CITY PLAN COMMISSION STAFF REPORT

Bodhi Residential Development

CD-CPC-2021-00100 -Rezoning with a plan

Report Date: October 15, 2021
Case Number: CD-CPC-2021-00100
Project: Bodhi Residential Development

A202

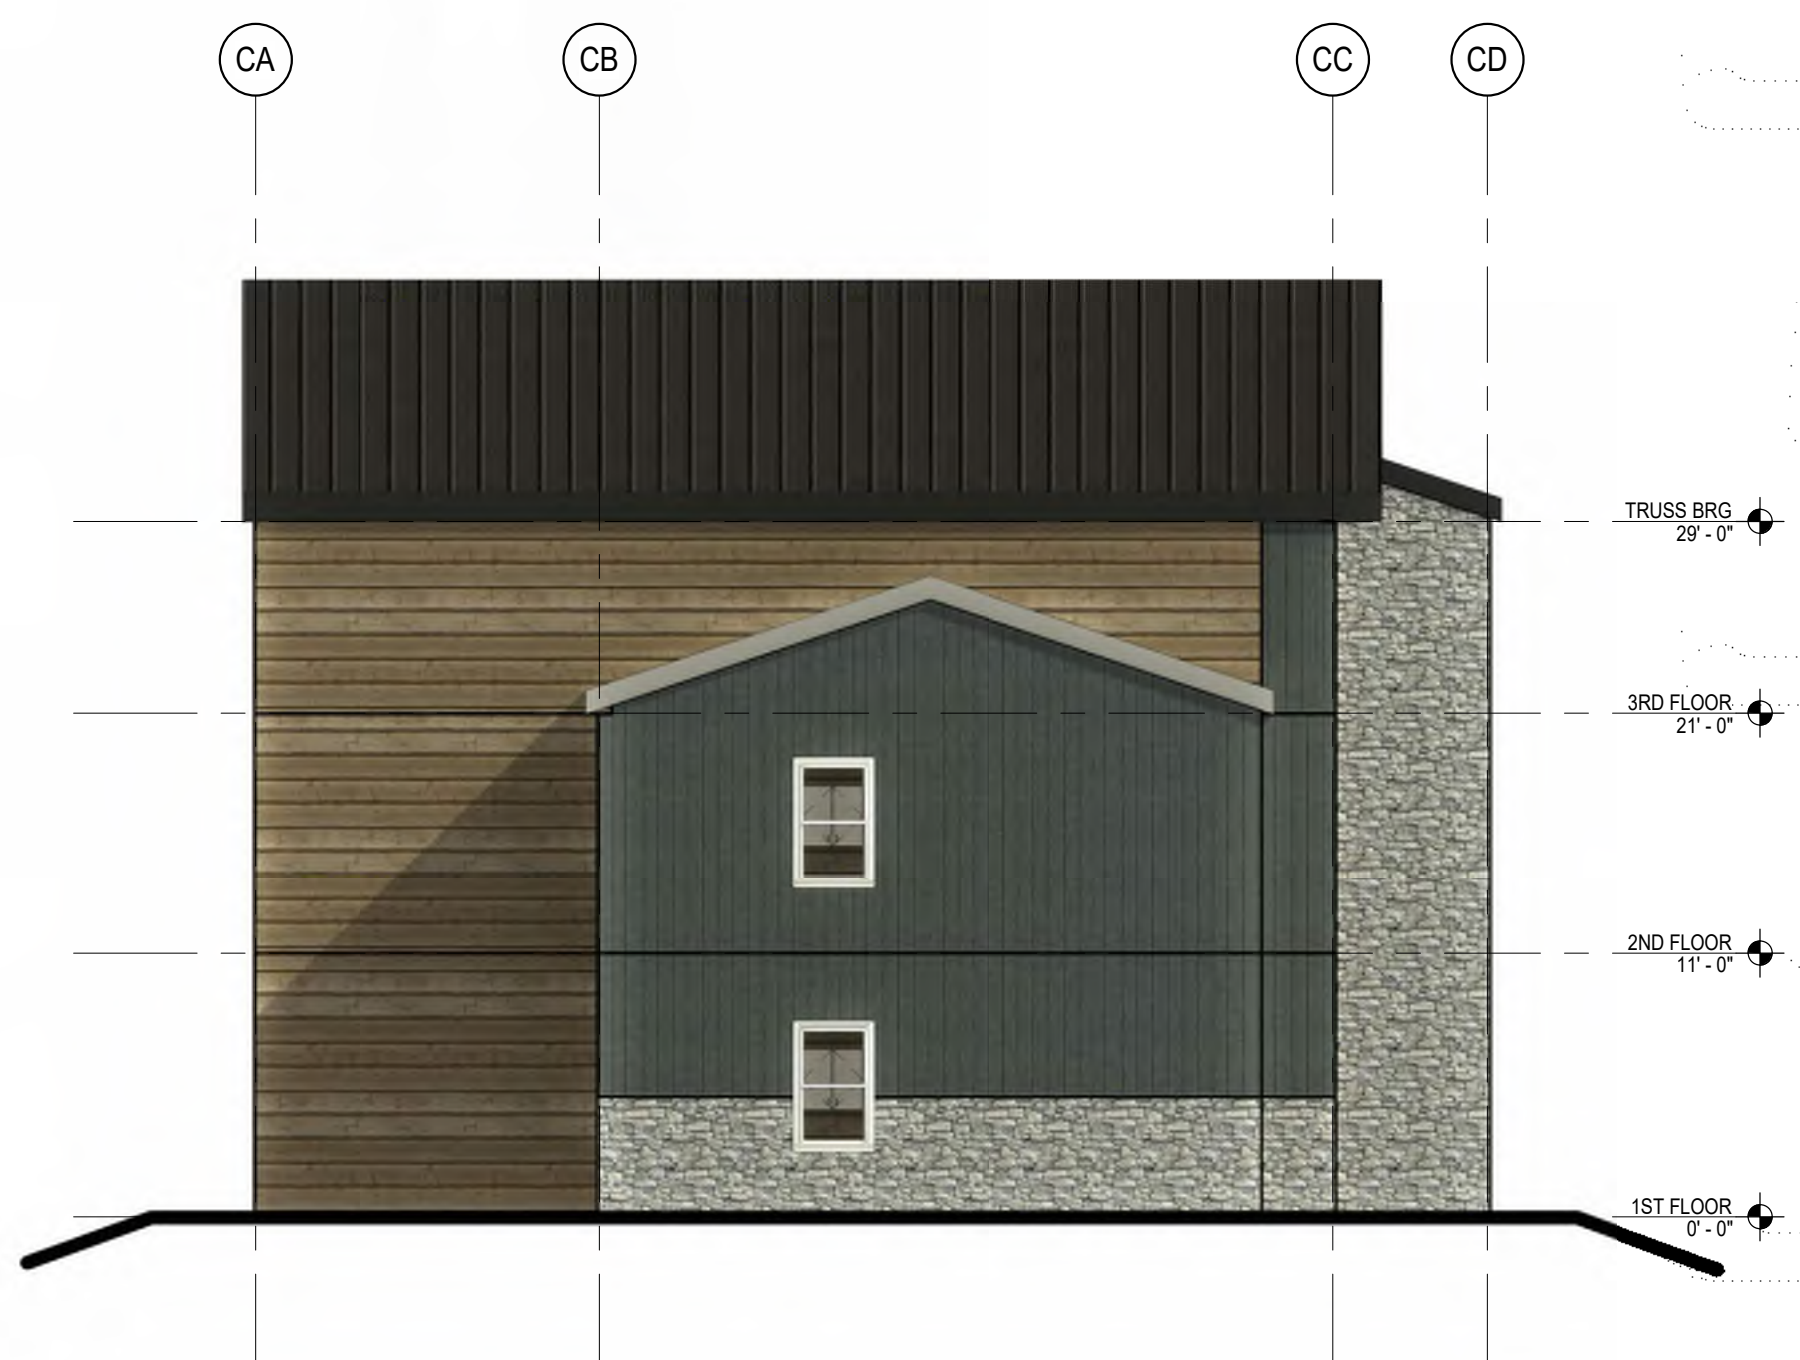
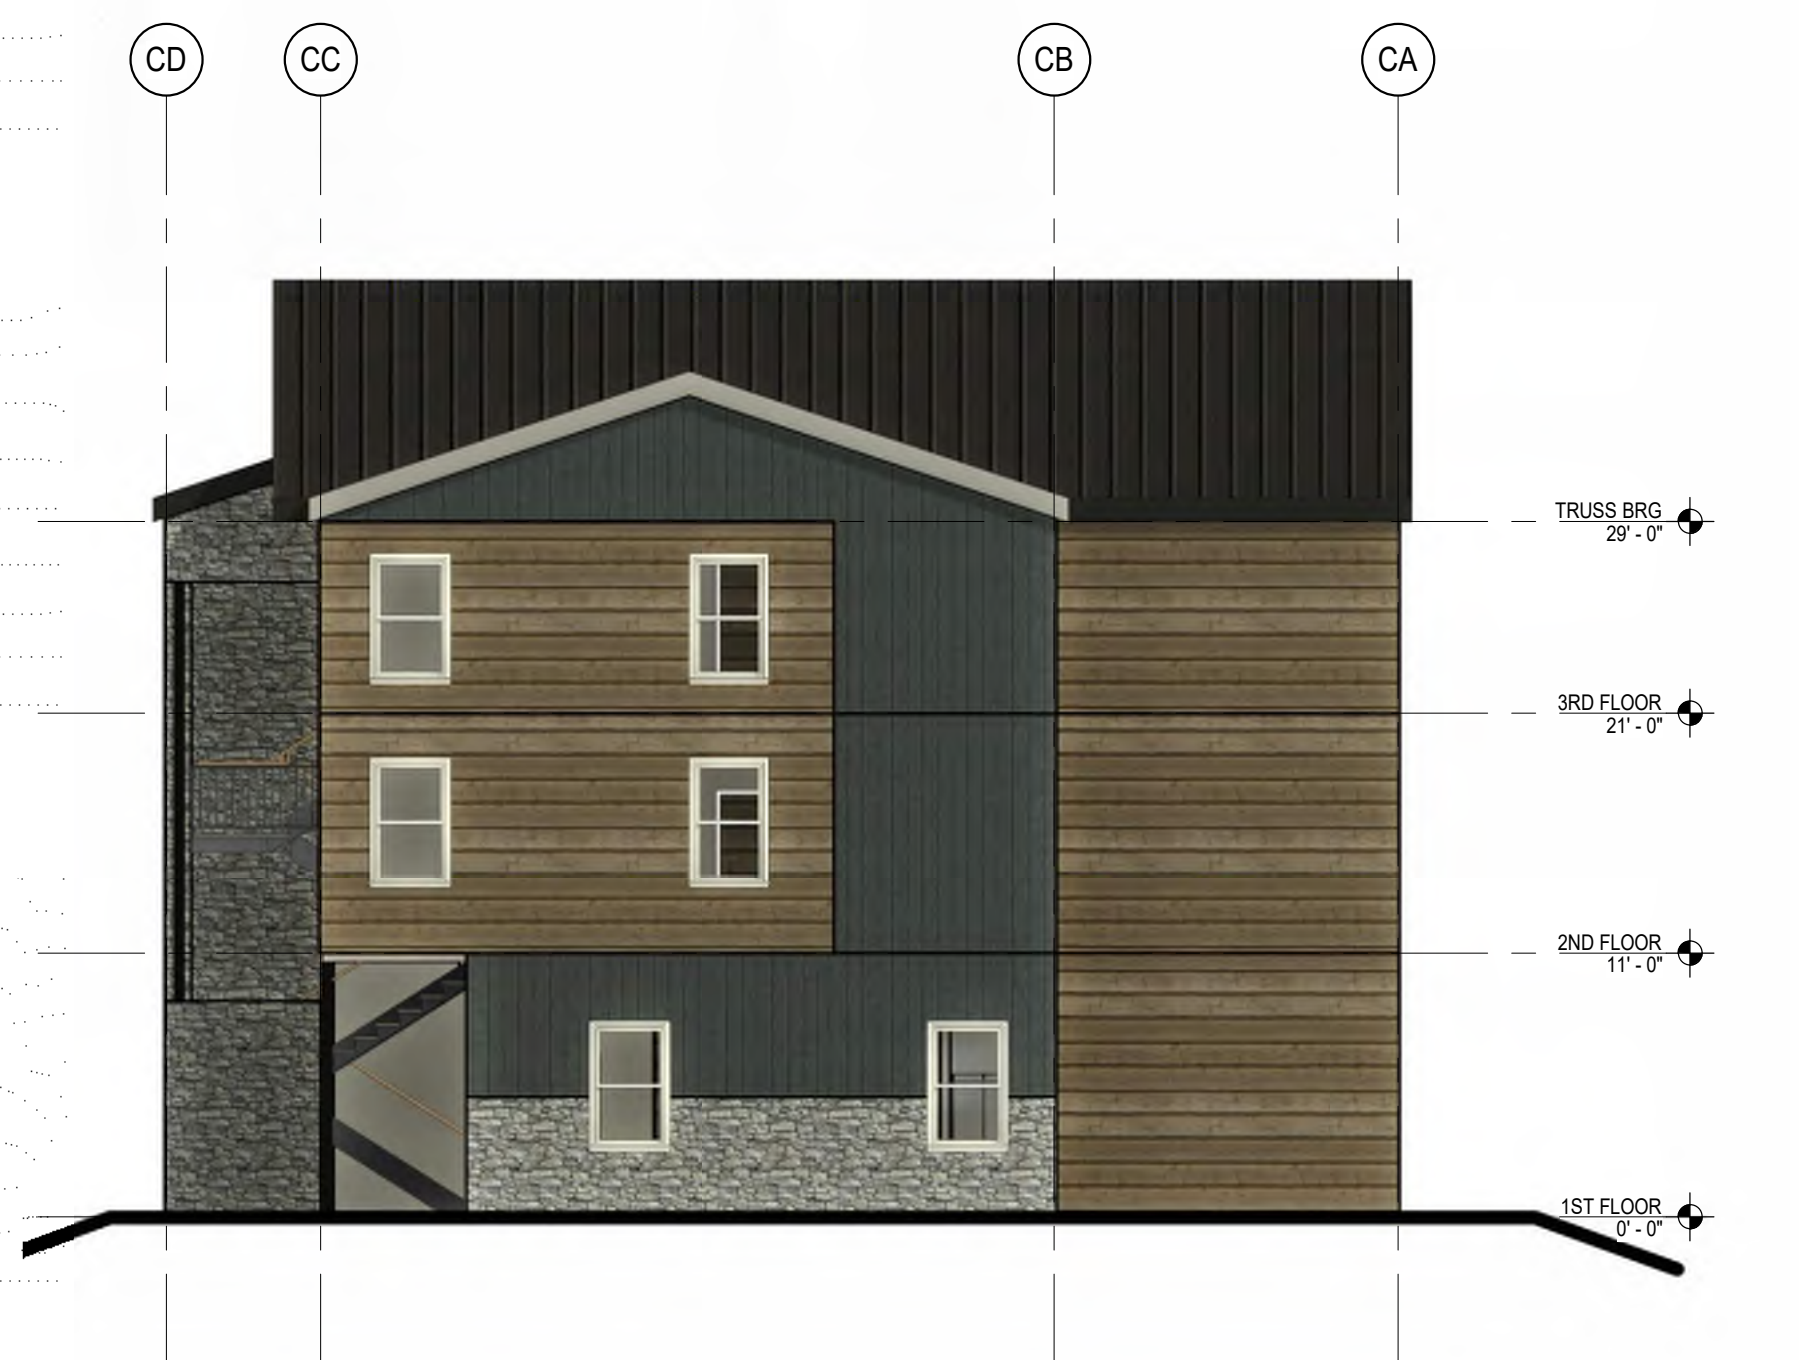
The 3-story apartment buildings are proposed to be primarily fieldstone veneer, horizontal and vertical lapping with asphalt shingles. Staff recommends additional information prior to ordinance request.

5. Show all revision dates on the cover sheet. Revise Plans and Resubmit (10/15/2021)
6. All pertinent information on the building elevation sheet including architect and developer information. Revise Plans and Resubmit (10/15/2021)

18. That the developer provide detailed architectural information on the proposed building for review and approval by staff prior to ordinance request or submit a design guideline for the proposed development. The design guidelines shall call out how this plan incorporates the Heart of the City Area Plan design guidelines wherever the opportunity presents itself. The guidelines shall call out all preferred and prohibited building materials. (10/15/2021)
